COUNCIL ASSESSMENT REPORT

Panel Reference	PPSSSH-150
DA Number	Mod 2023 / 0019
LGA	Georges River Council
Proposed Development	Section 4.55 application to modify Development Consent No 12/DA-132 for a mixed use development for additional GFA, increased heights at Forest Rd by (1) storey and Hill St tower by (3) three storeys, reconfiguration of basement levels to cater for additional parking and storage, and conversion of south facing balconies on Hill St end to winter gardens.
Street Address	105 Forest Road and 1A Hill Street, Hurstville Lot B DP 421265 Lot A DP 421265
Applicant/Owner	Applicant- Mrs Susan Tsang & Lee Architects Pty Ltd (H3 Architects) Owner – Forest Road Holdings Pty Ltd
Date of DA lodgement	23 January 2023
Total number of Submissions Number of Unique Objections	Two (2) submissions received.
Recommendation	Refusal
List of all relevant s4.15(1)(a) matters	<ul style="list-style-type: none"> • Environmental Planning and Assessment Act 1979. • Environmental Planning and Assessment Regulation 2021. • Water Management Act 2000 • State Environmental Planning Policy (Resilience and Hazards) 2021. • State Environmental Planning Policy (Transport and Infrastructure) 2021 •

Figure 13: Forest Road Tower Modification — Level 13 Floor Plan

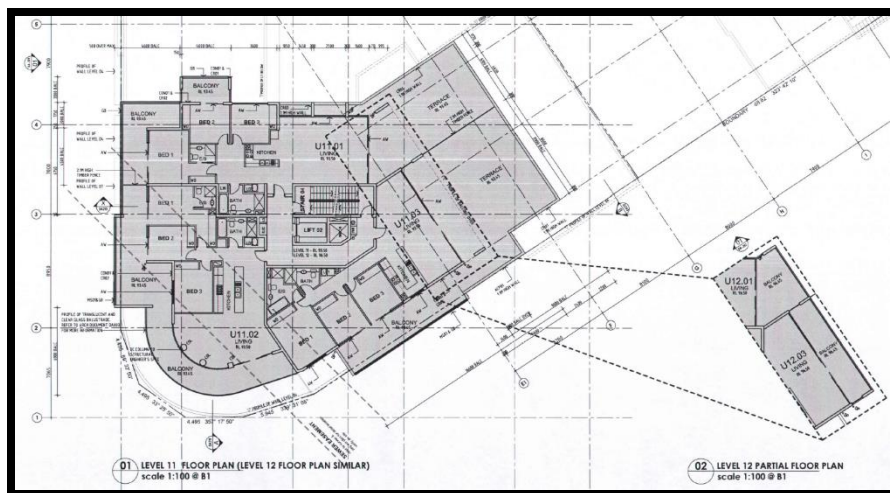
- The proposed additional storey mirrors the six (6) unit layout of Level 12 for a total of eleven (11) bedrooms, as follows:
 - 1 x 1 bedroom unit
 - 3 x 2 bedroom units
 - 1 x 3 bedroom unit
 - 1 x 1 bedroom adaptable unit
- However, this layout departs from the previously approved Level 12 layout which provided three (3) units for a total of nine (9) bedrooms, as follows:
 - 3 x 3 bedroom units

Figure 15: Forest Road Tower Modification — Level 14: Terrace Roof Plan

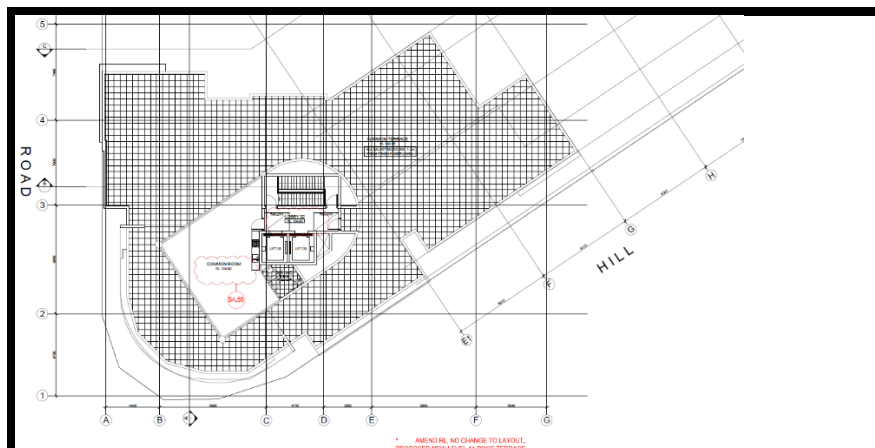
- Although the modified roof terrace plans — Level 7 (Hill street tower) and Level 14 (Forest Road tower) identify “Common Terrace” areas, there is no landscape plan for the modified development.

Figure 23: Modified Hill Street Elevation — Approved and proposed south-facing balconies to be converted into wintergardens (shown in blue).

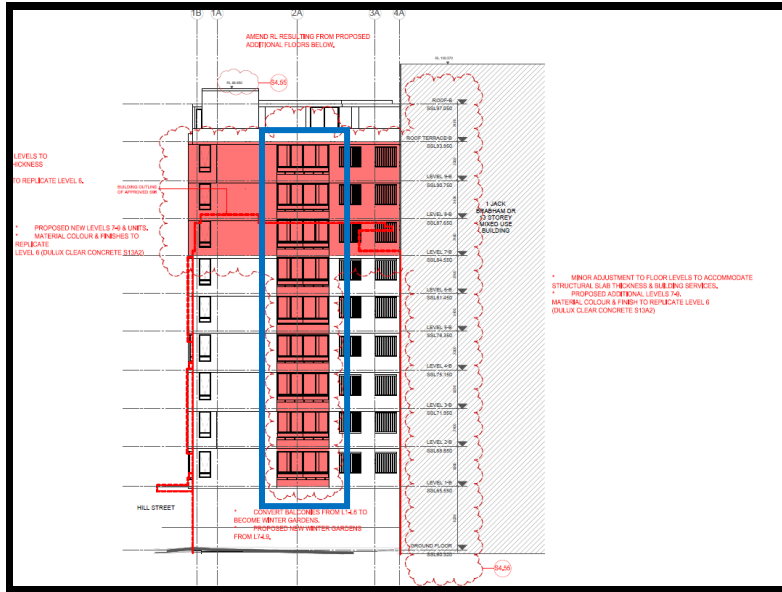
proportion to the streetscape and human scale.	approved apart from the creation of winter gardens to all south facing apartments. The increased height and overall bulk however diminish achievement of an appropriate planned streetscape.	
4N – roof design	Roof treatments are integrated into the building design and positively respond to the street. Opportunities to use roof space for residential accommodation and open space are maximised. Incorporates sustainability features.	No detail provided in relation to plant provision on the roof which had been previously approved. Communal open space areas shown on the roof to both buildings but without detail. No additional facilities or size proposed for additional apartments.	No
4O – Landscape Design	Landscape design is viable and sustainable, contributes to the streetscape and amenity	No landscape plan submitted. SEE states a reduction in landscape area from 1755 m ² (66%) site area to 1527 m ² (57.9%) site area. (Source: Council's Landscape referral comments)	No
